NORME
INTERNATIONALE
INTERNATIONAL
STANDARD

60821

AMENDEMENT 1
AMENDMENT 1

**VMEbus –
Microprocessor system bus
for 1 byte to 4 byte data**

Figure 4-8 – Release of the interrupt request lines by ROAK and RORA INTERRUPTERS

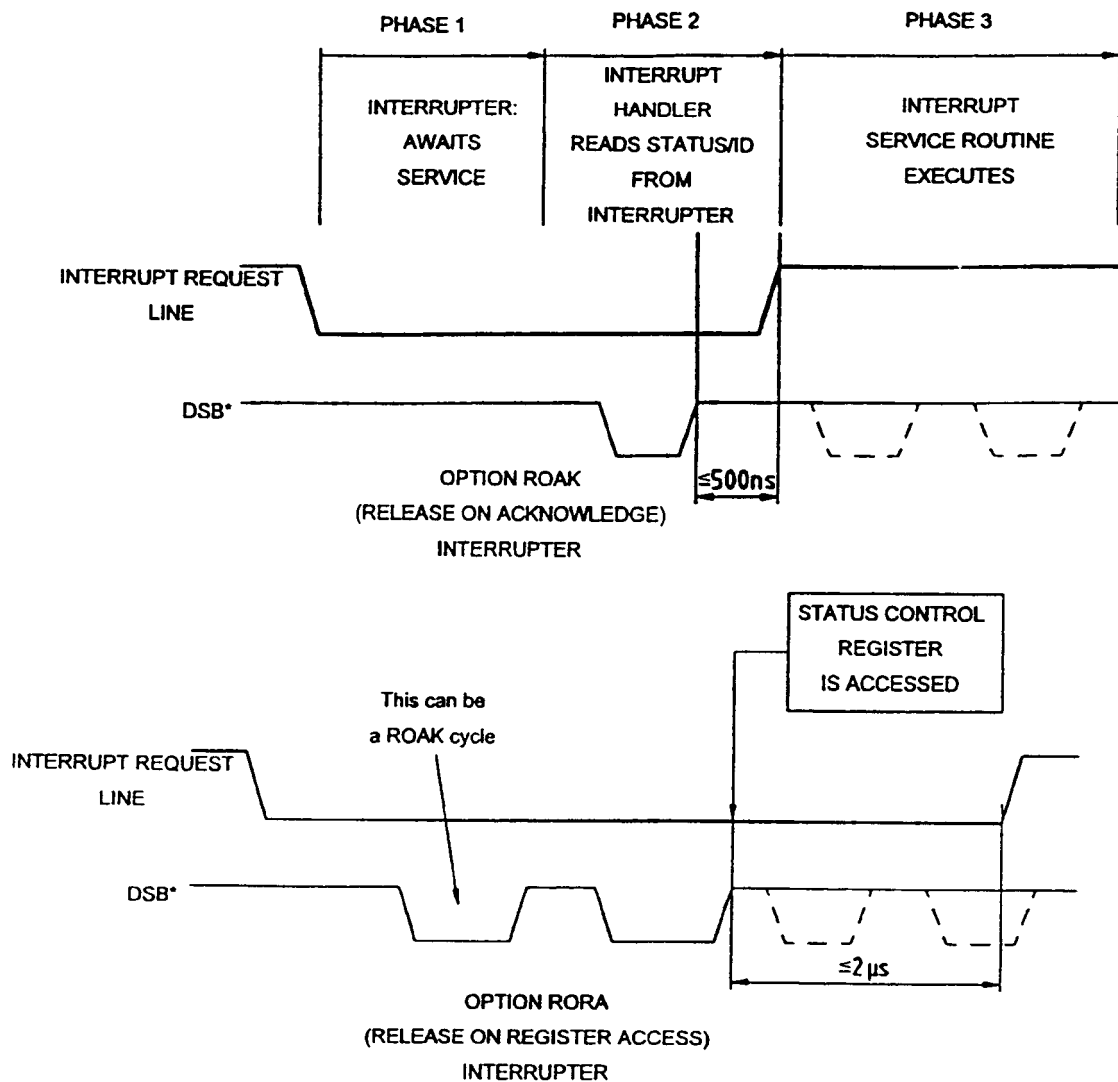
Replace figure 4-8 by the following new figure:

Figure D-5 – VMEbus arbitration structure; dashed circles indicate where critical input conditions can arise
a) simplified block diagram;
b) control signals, with evidence of the handshake loop (MASTER - REQUESTER - ARBITER - REQUESTER - MASTER)

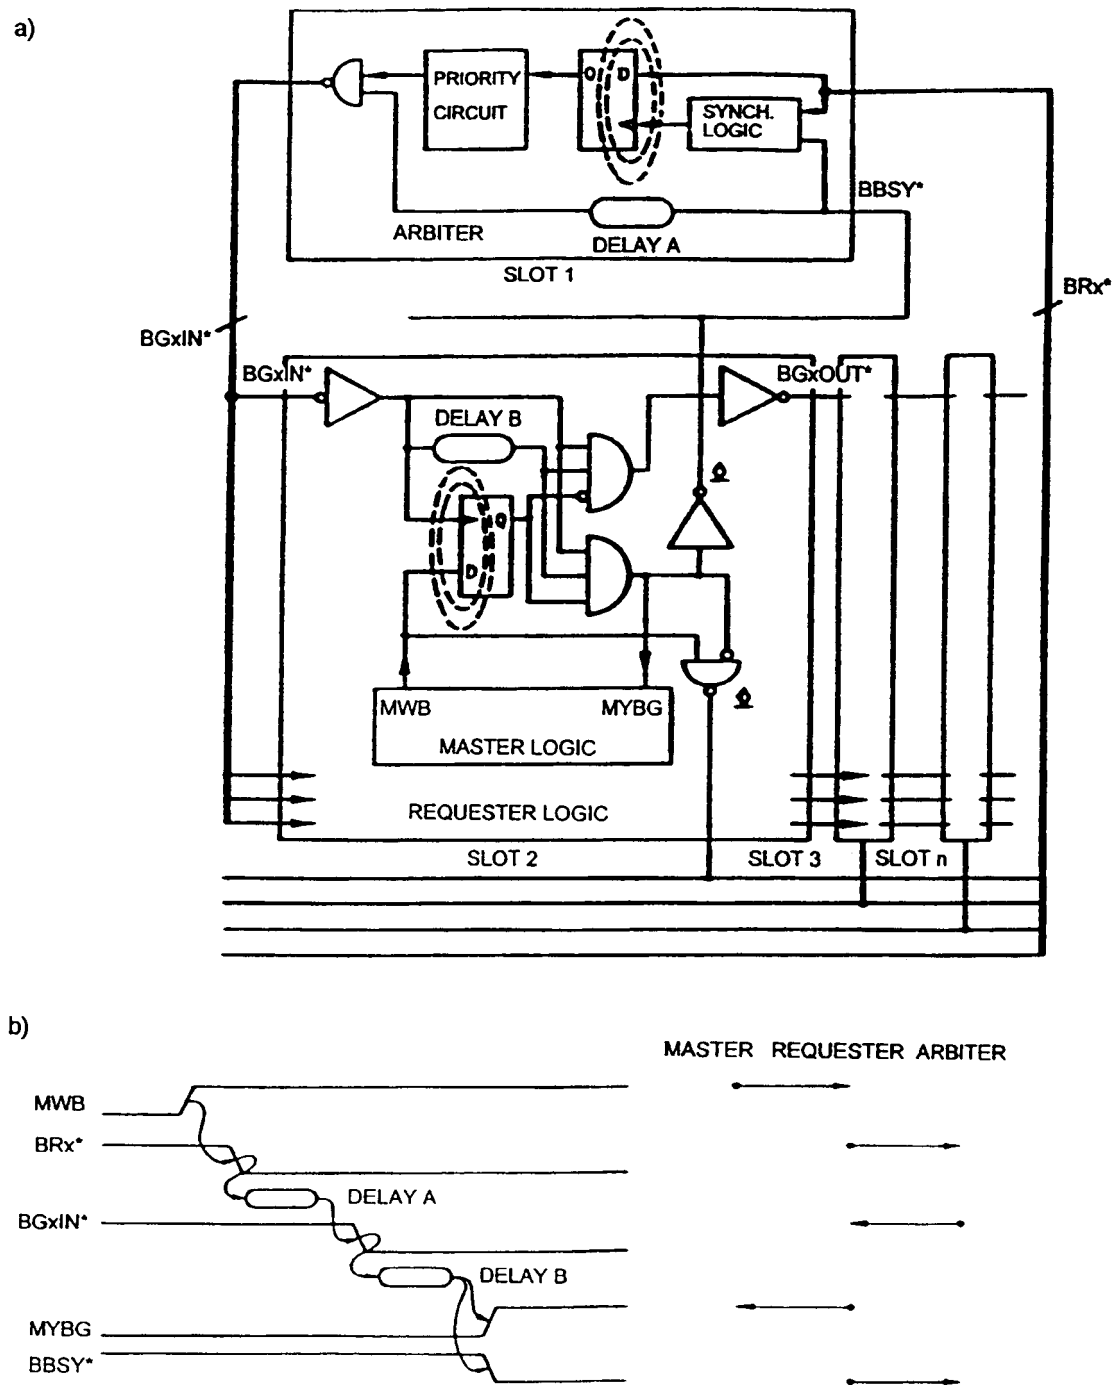
Appendix D – Metastability and resynchronisation*Add, under the title of this appendix, the term "informative".**Replace, on page 527, figure D-5 by the following new figure:*
